Title - Sujet : Tunnel Mountain Operations Shallow Utilities, Banff National Park	
Solicitation No. - N° de l'invitation : 5P421-21-0050/B	Date : May 10, 2022
Amendment No. - N° de modification : 001	
Client Reference No. - N° de référence du client :	
GETS Reference No. N° de référence de SEAG : PW-22-00993453

Amendment 001

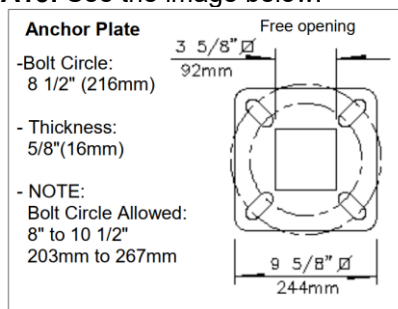
Q15: Do you have shop drawing of light pole you are providing? Specifically looking for confirmation on BCD (bolt center diameter) of pole.

A15: See the image below.
